City of Dublin

Memo

Re: Master Sign Plan – CML, Dublin Branch and Downtown Dublin Parking Garage Signs – (Case#17-125MSP)

NORTH ELEVATION

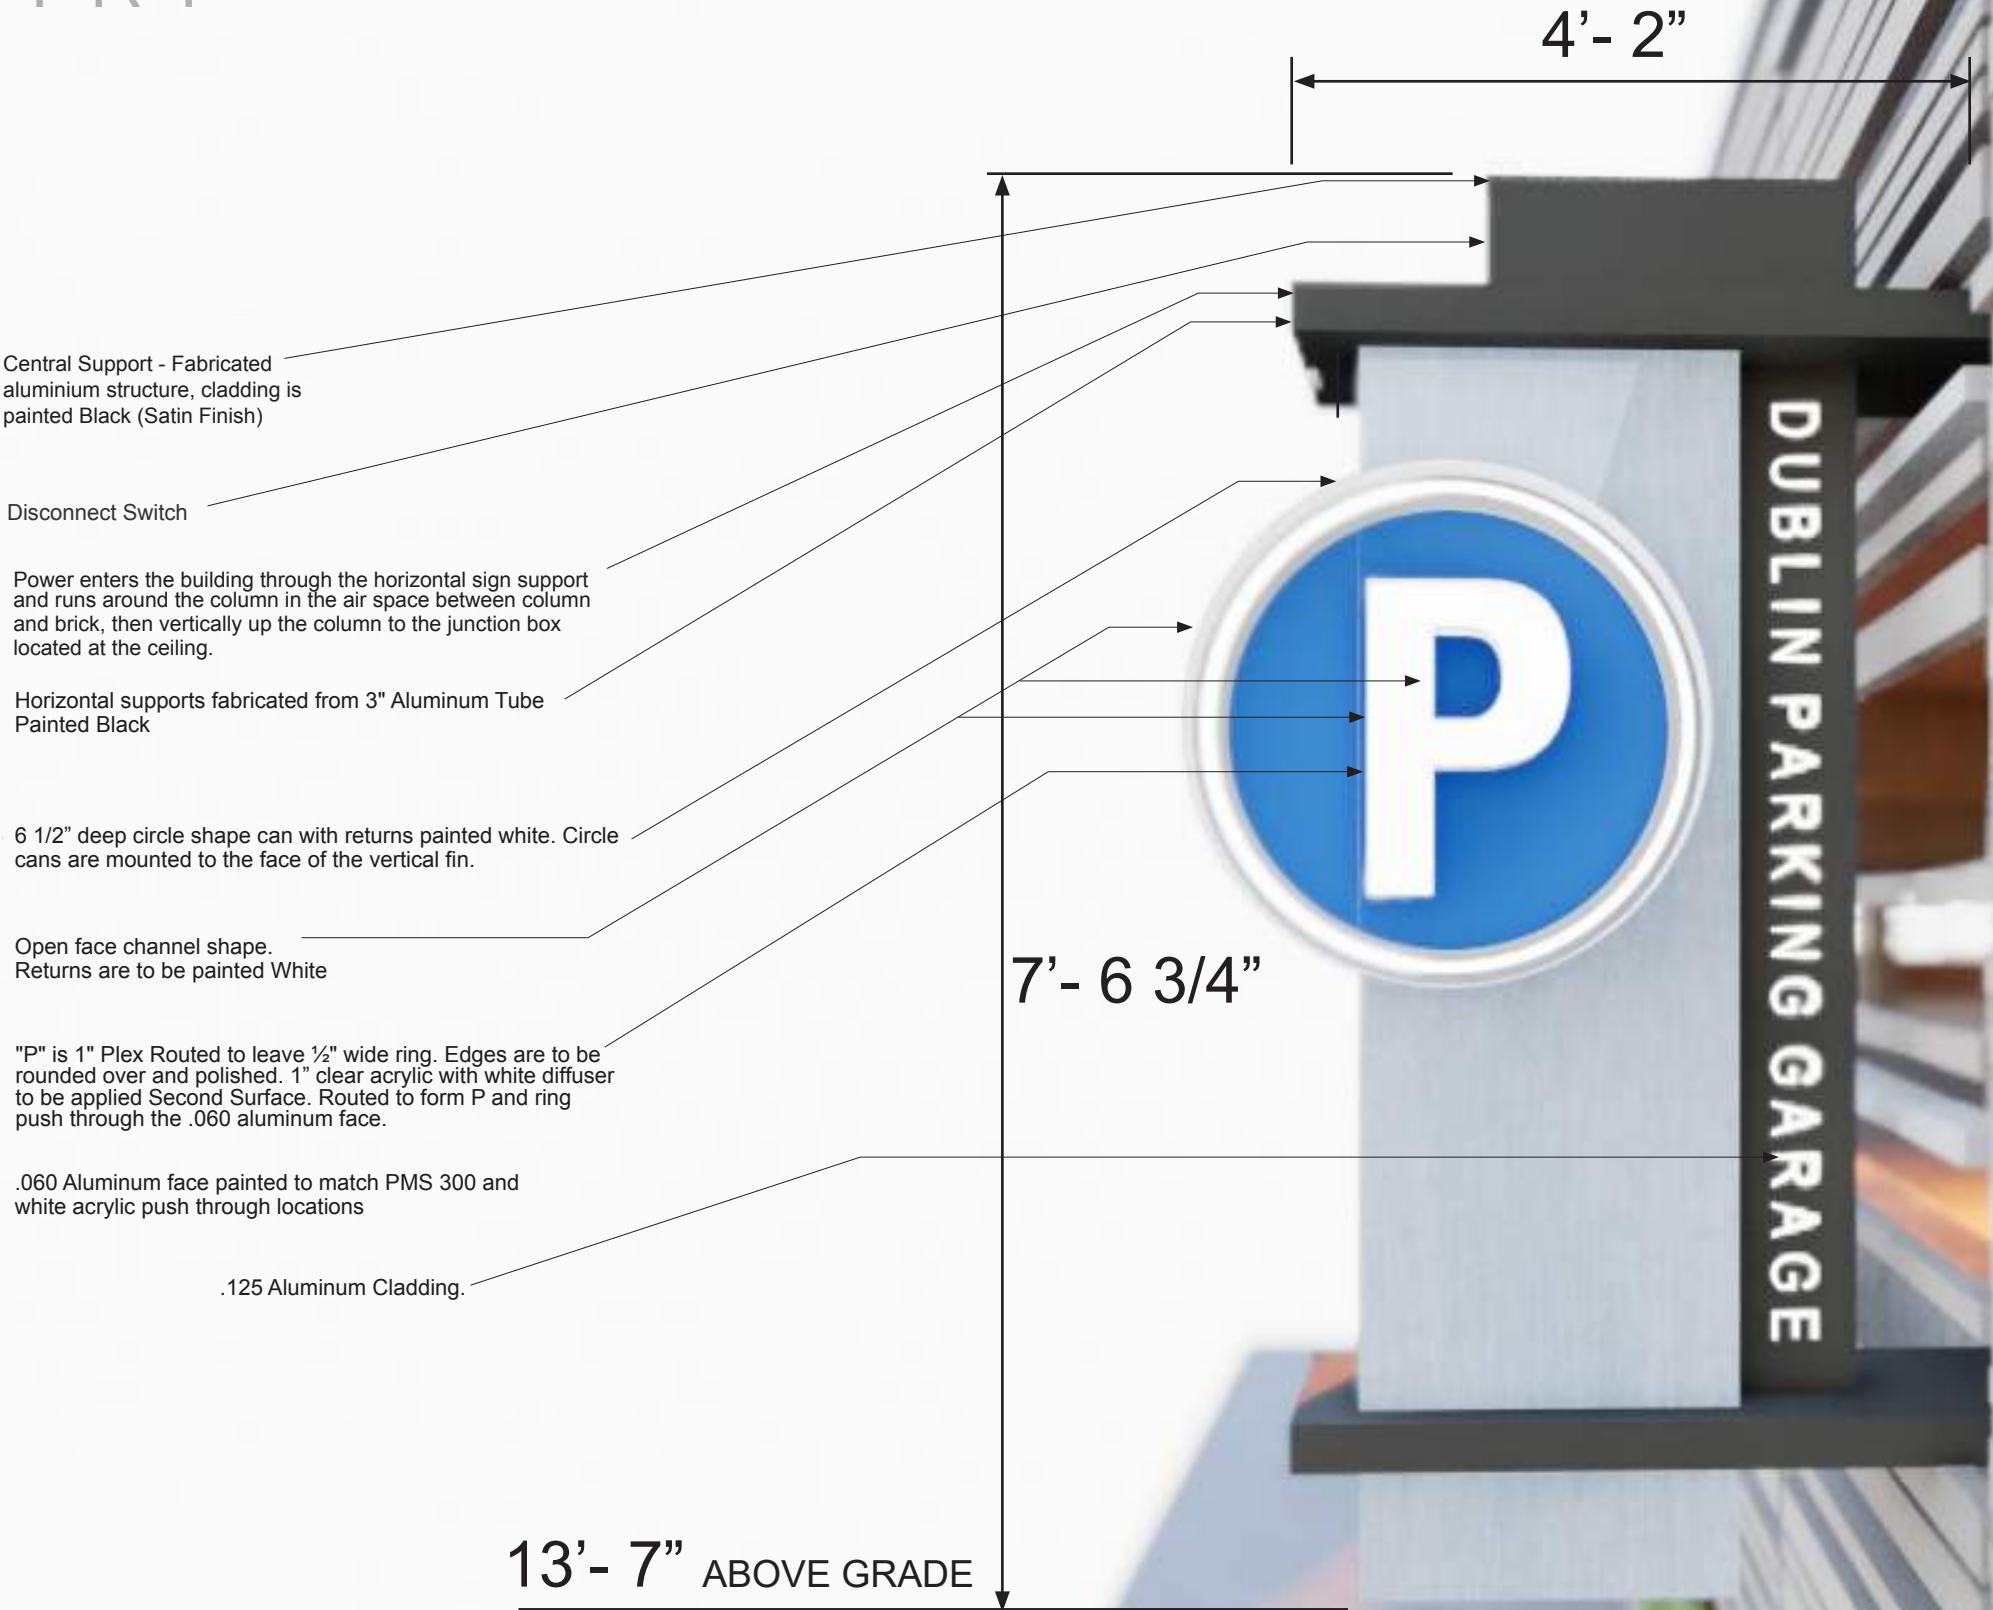
The proposed sign plan indicates additional graphics located within the interior of the garage at the North Street entrance. The ART understood these graphics may change over time and recommended an additional sign type be added to the Master Sign Plan to allow for these internal graphics visible from the right-of-way.

Ms. Rauch presented a view of the parking garage on North Street and asked the ART if a condition should be added concerning a sign type for graphics. She said that in this instance, the graphic is on the large wall, inside the garage but noted the graphic is far back. Vince Papsidero said he did not think it would be an issue but thought our records should legitimize it. Ms. Husak questioned whether the graphic is a sign or not. She noted there is a stipulation in the Code that states interior signs need to be three feet back from wall or window but in this case, there is no wall/window in front of it as it is visible on the back wall as seen through the opening of the garage. She said there will be times when there are cars parked in front of it, blocking it from view. Ray Harpham suggested the graphic on that back wall is not a deal breaker. Ms. Husak recommended this graphic be considered an interior wall graphic and the ART should determine a size limit.

The proposed sign plan indicates additional graphics located within the interior of the garage at the North Street entrance. Planning understands these graphics may change over time and recommends an additional sign type be added to the Master Sign Plan to allow for these internal graphics visible from the public right-of-way.

NORTH WEST STAIR

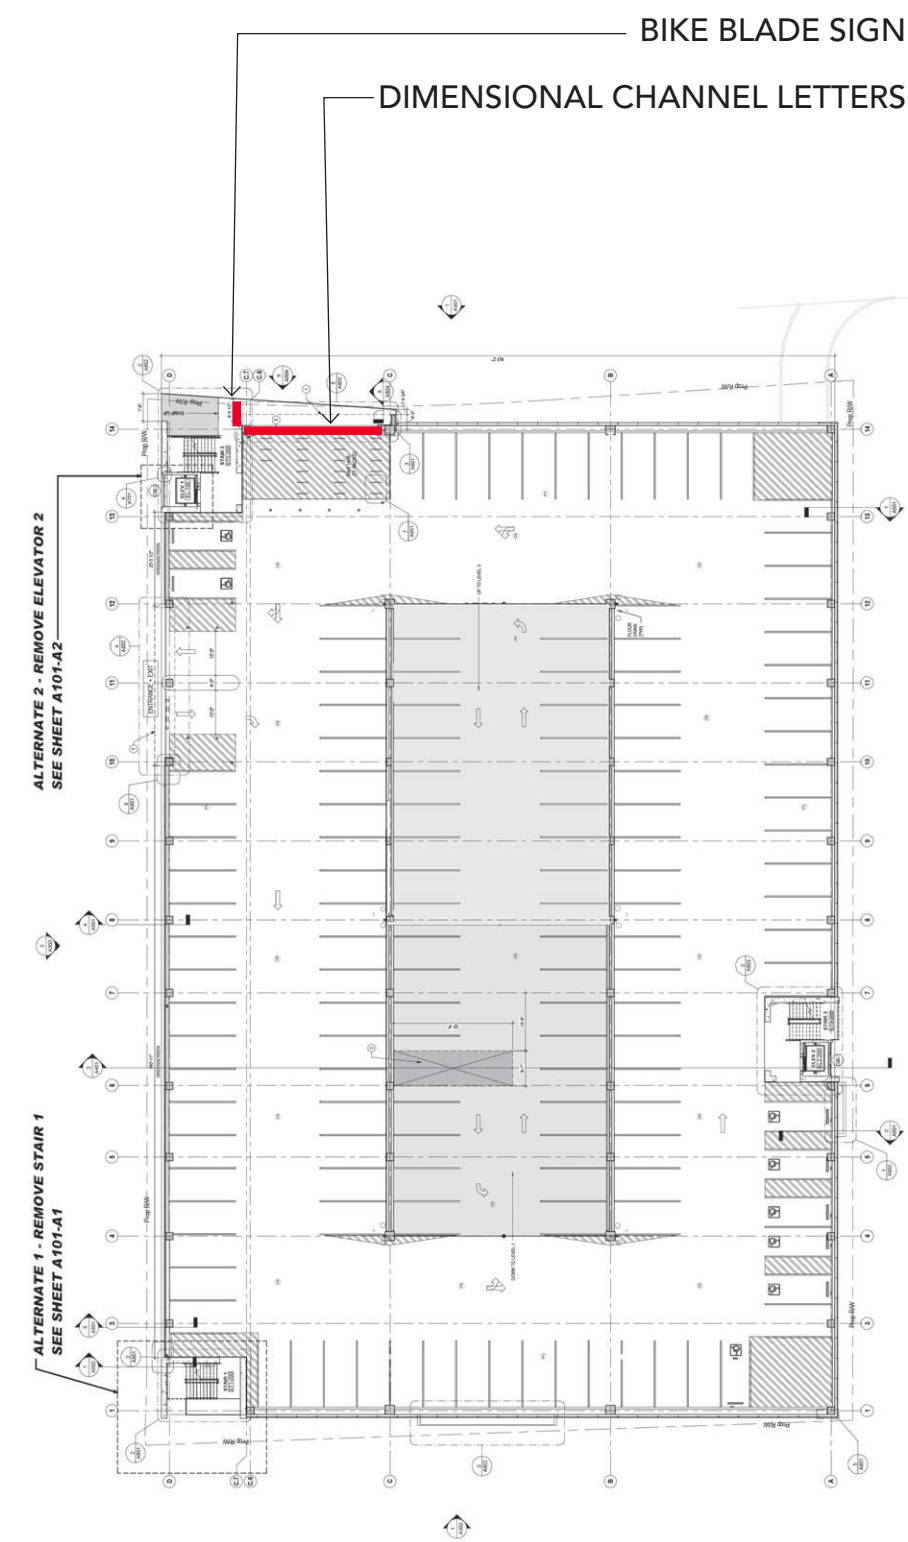
Ms. Rauch reported the permanent signs for the garage were all deemed appropriate with the exception of the large colored numerals to designate each floor. She reported the consensus of the ART at that time was that the floor numerals were too large and requested more dimensional detail for review. She identified the numerals inside the stairwell and stated that the numerals extend from the base of the floor to the top of the opening with each number being a different height and size. She recommended that all the numbers be of a similar size to provide consistency in the design.

The northwest stair tower was presented and Ms. Rauch noted how each floor had a large colored numeral to designate the floor, each being a different color. She asked the ART for feedback on the floor numerals and some team members thought the size was too large but requested more dimension detail. The ART thought overall the numbers should be decreased in size both inside and outside the tower.
